ADDENDUM #2

Project Name:
Iowa School for the Deaf (ISD)
IDOE ISD Giangreco Hall Water Infiltration Mitigation
DAS# 9455.00
RFB 945500-01
Addendum #2
Dated: November 20, 2025

A1 EXTERIOR ELEVATION - WEST WING - NORTH
1/8" = 1'-0"

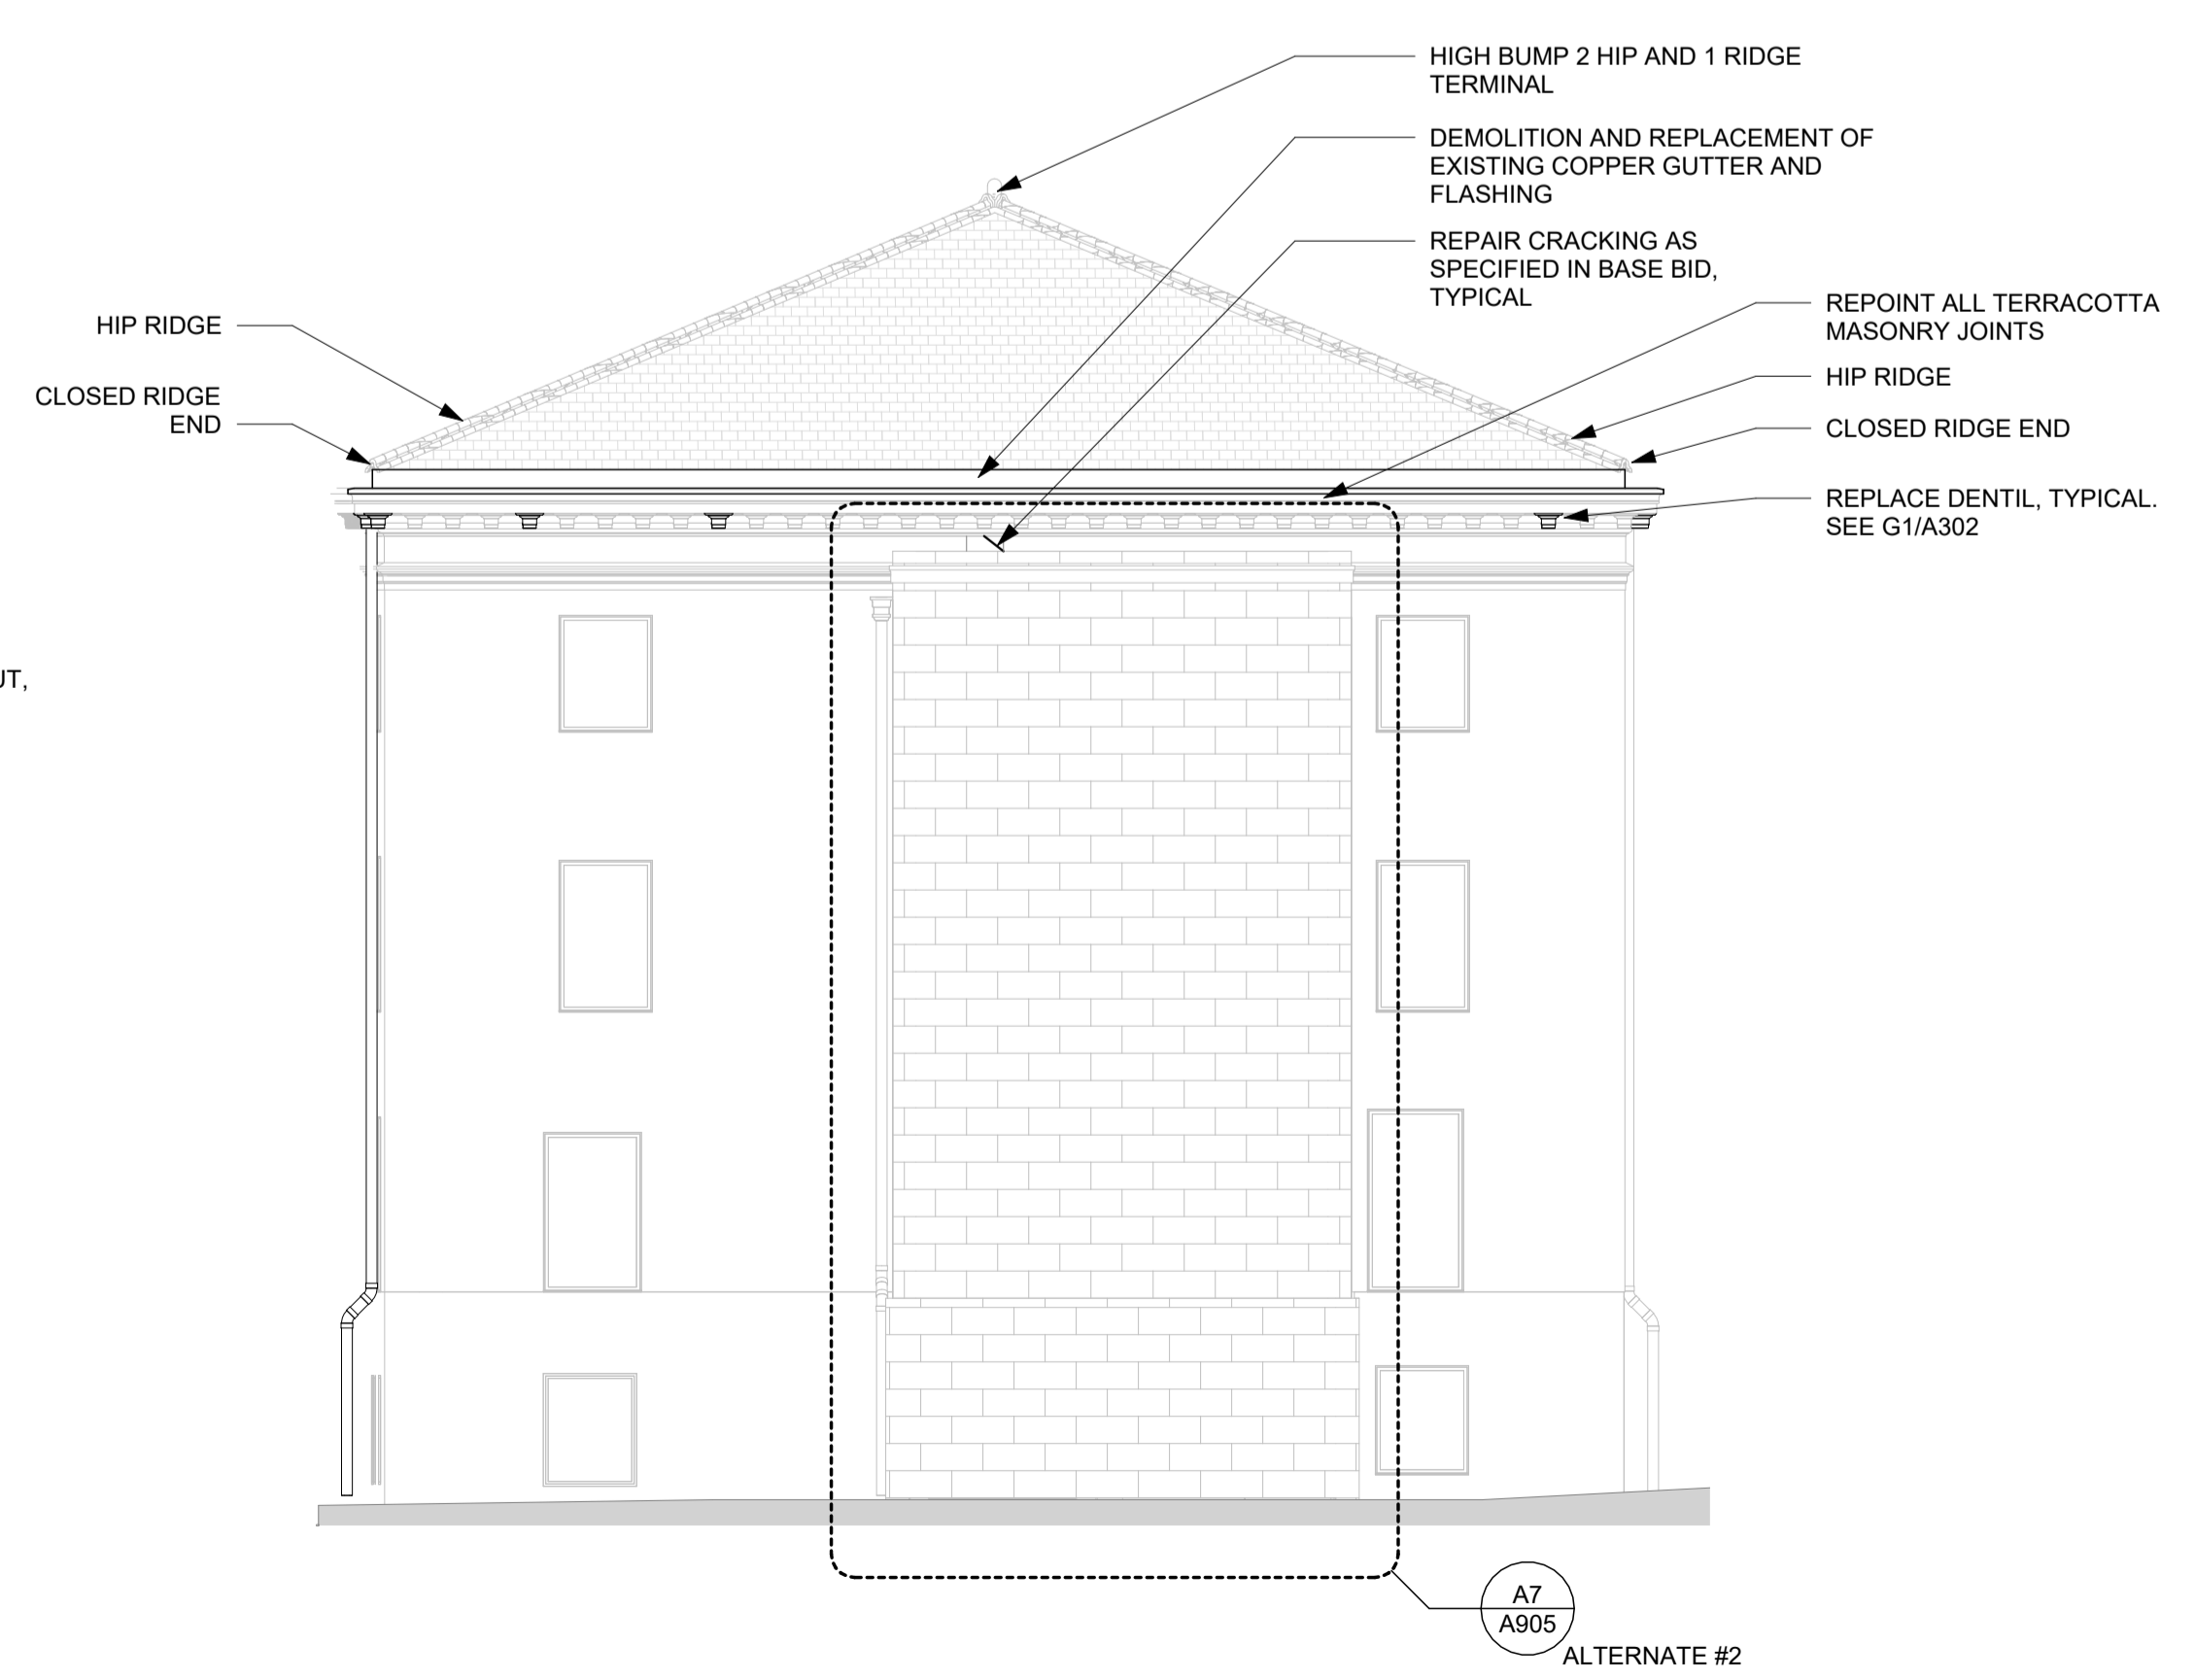
- 1. K1/A202 and A1/A202 – Detail callouts added at base of new downspouts.
- G. A203 Exterior Elevations – West
 - 1. K1/A203 and A1/A203 - Detail callouts added at base of new downspouts.

G1 PHOTO - TYPICAL TERRACOTTA UNIT
 1" = 1'-0"

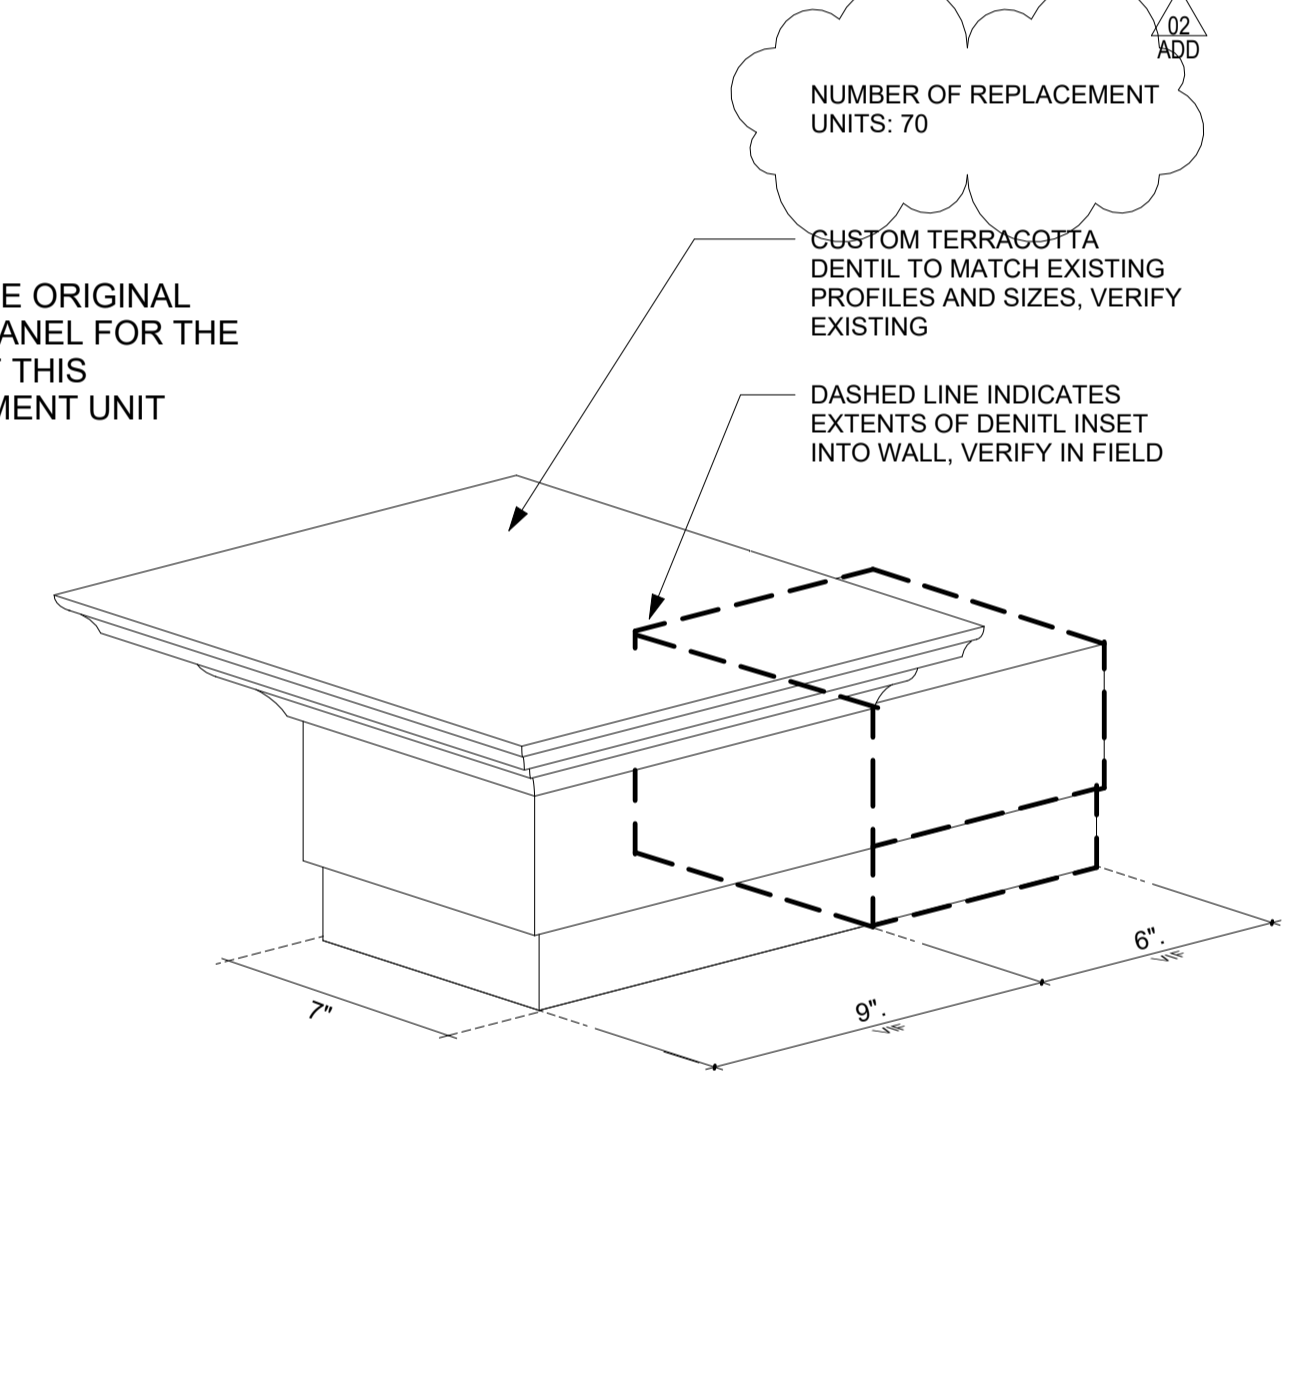
- I. A302 Roof Details
 - 1. A1/302 and G1/A302 – Photos added to details.
 - 2. A20, G5, G19, N1, N8, N16/A303 – Text added for number of replacement units.

A1 PHOTO - STANDING SEAM AT COPPER
1" = 1'-0"

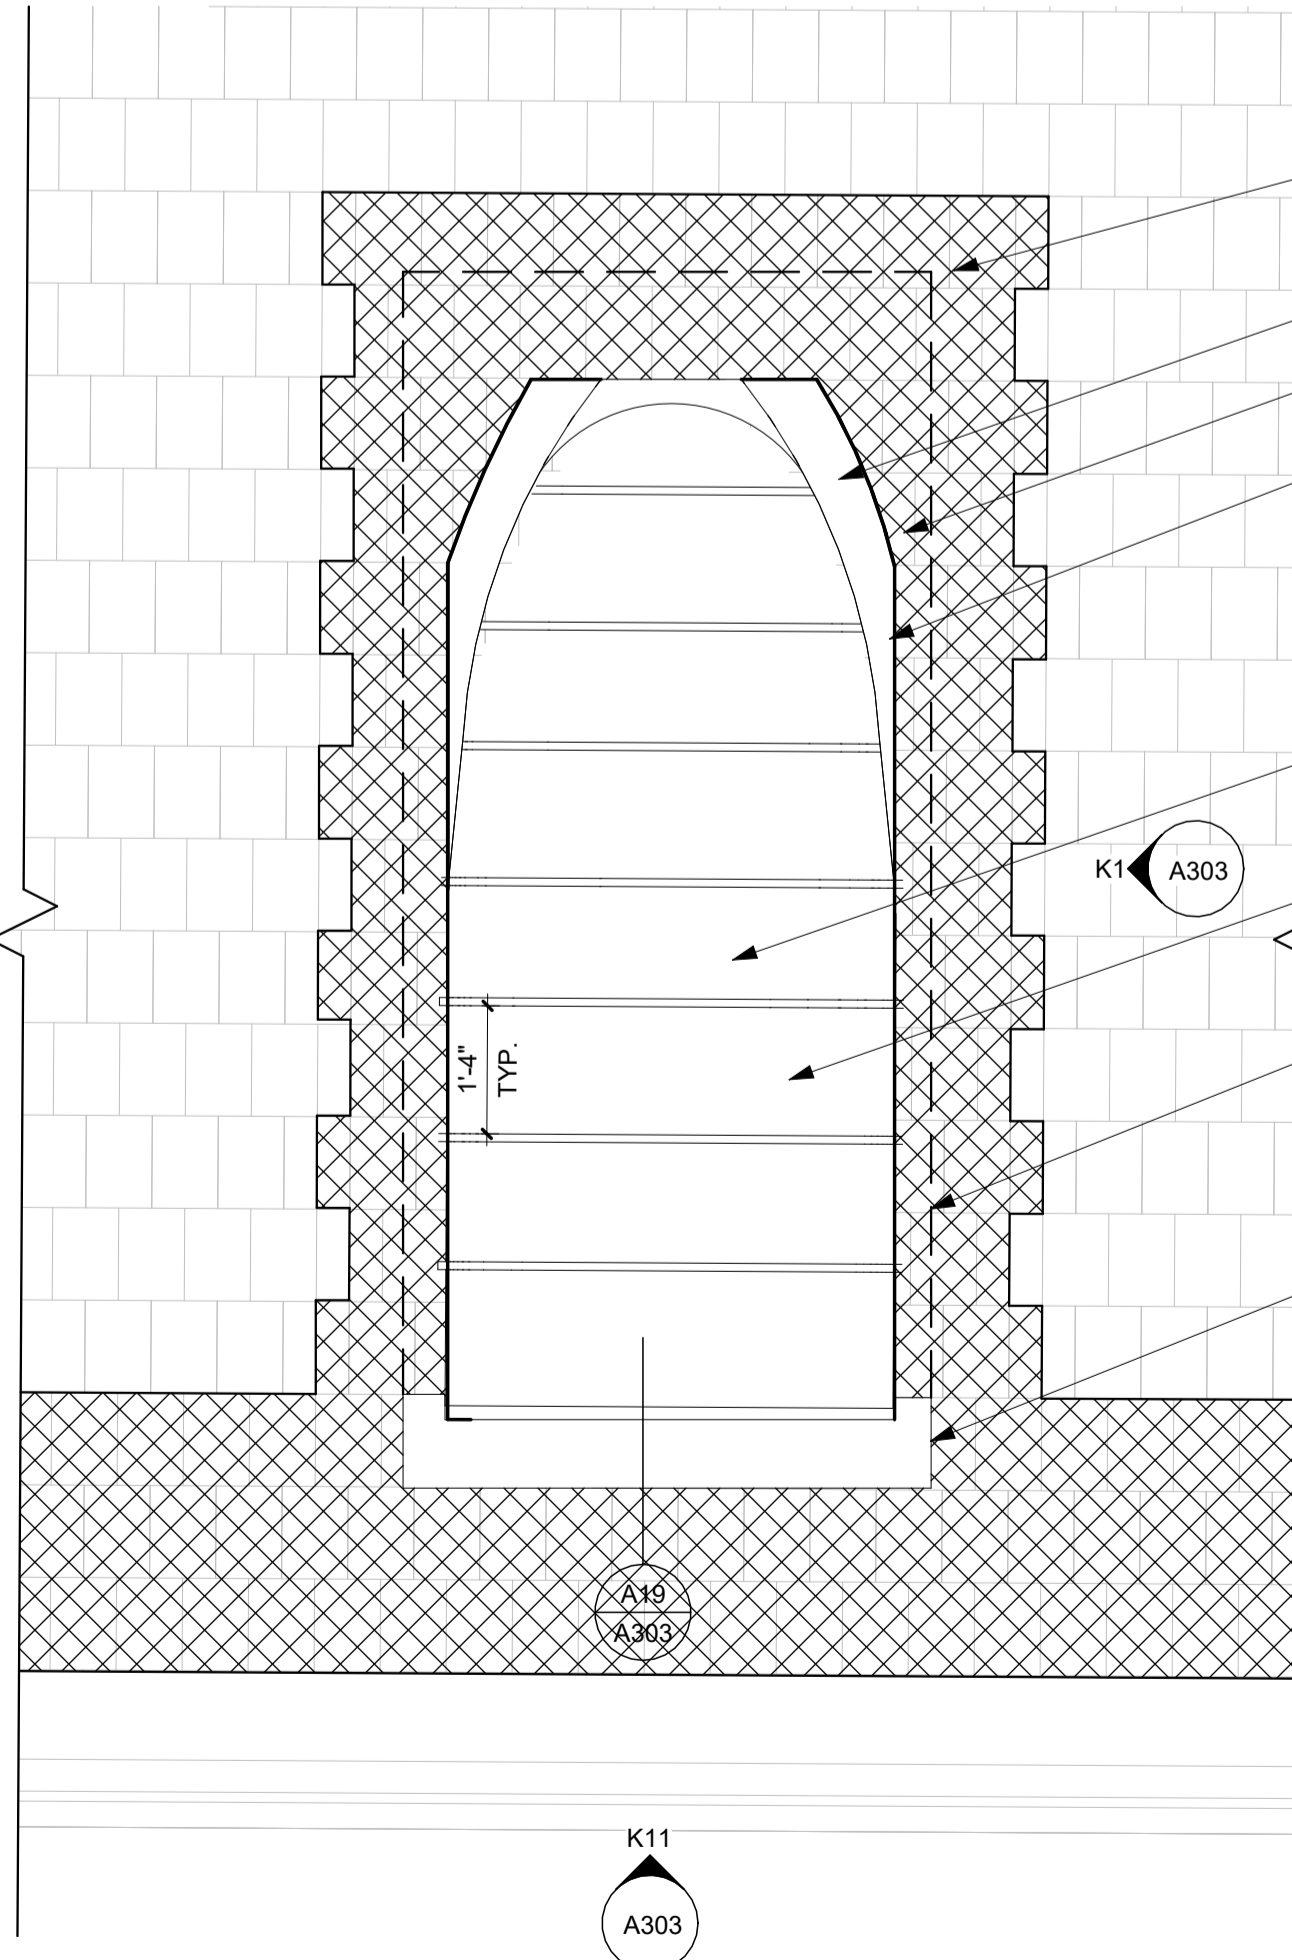
- J. A303 Roof Details
 - 1. A1/A303 – Detail added including photo of copper standing seam condition.
 - 2. A11/A303 – “16 OZ.” copper text deleted from four locations.
 - 3. A19/A303 – “16 OZ.” copper text deleted from one location.
 - 4. K1/A303 – “16 OZ.” copper text deleted from three locations.
 - 5. K11/A303 – “16 oz.” copper text deleted from three locations.
 - 6. K19/A303 – “16 OZ.” copper text deleted from two locations.
 - 7. Q19/A303 – “16 OZ.” copper text deleted from two locations.

- b. Add paragraph 3.09 Schedule; “A. Copper standing seam for the dormers and typical detail A1/A303: 20 oz. copper.”
4. Section 07 6200 Sheet Metal Flashing and Trim
